Enclosed is the response to the violations license #40-01683-01 that the Department of Nuclear Medicine at Sacred Heart Hospital were sited for on the N.R.C. inspection of 10/24/90. I believe that we have corrected all the discrepancies and are now in line with the N.R.C. regulations.

REPLY TO NOTICE OF N.R.C. VIOLATIONS - LICENSE #40-01683-01

\*\* EXHIBIT B \*\*

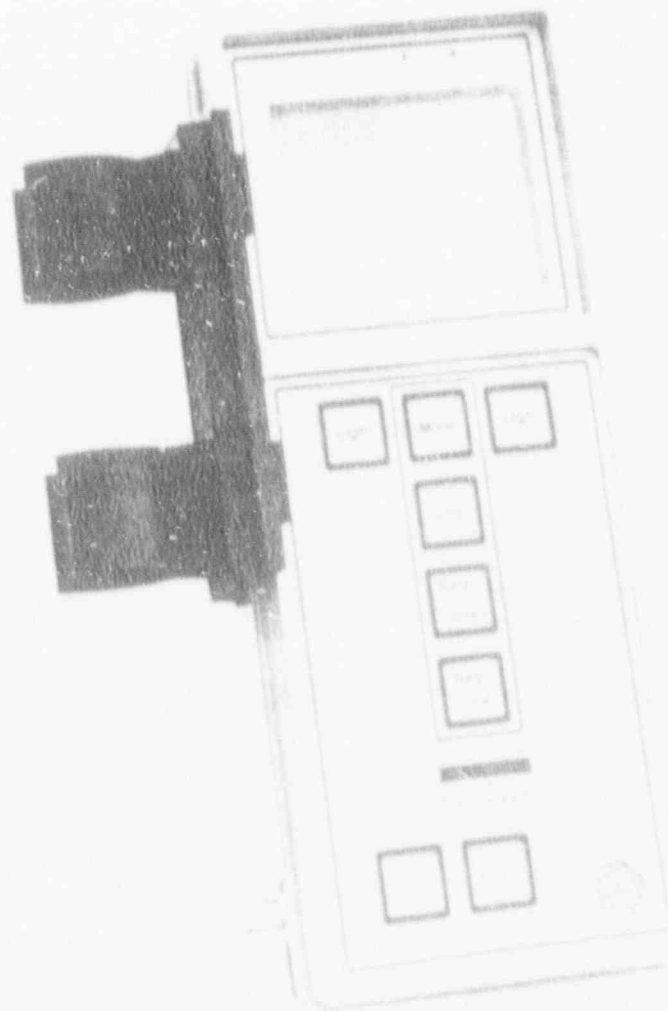
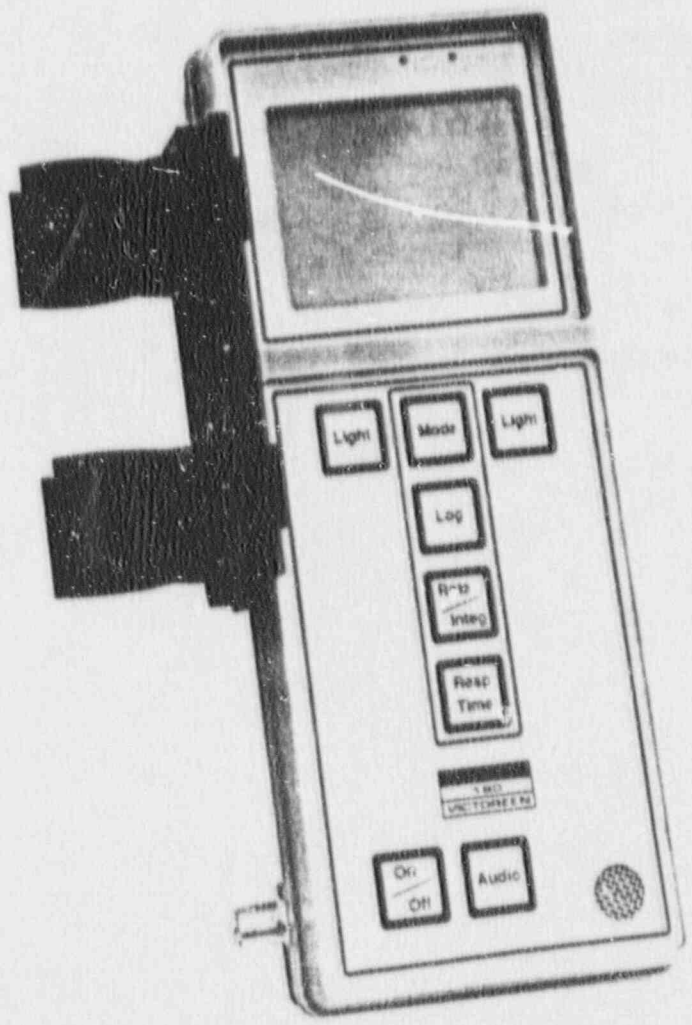
In regards to #2 - 10 CFR 35.51 (a) (2) - Sacred Heart Hospital Department of Nuclear Medicine did not calibrate the Victoreen Model 592B and Nuclear Chicago 2612 survey instruments using two separate readings on each scale of use during calibrations in October, 1988, and November, 1989, for Victoreen instruments and July, 1989, for Nuclear Chicago instruments.

Department of Nuclear Medicine failed to calibrate the Nuclear Chicago instruments such that the indicated exposure rate differed from the calculated exposure rate by less than 20% or to attach a correction chart or graph to the instrument when indicated exposure rates varied as much as 10% from the calculated value for calibrations done in June, 1988, and July, 1989.

CORRECTIVE ACTION TAKEN: The Nuclear Chicago survey instrument Model 2612 has been replaced with a Victoreen Survey and Count Meter Model 190 (See enclosed Exhibit B). Department of Nuclear Medicine has also signed an agreement to have Victoreen calibrate both the Victoreen Model 592B and Survey and Count Meter Model 190. This new agreement will assure compliance with N.R.C. Regulations.
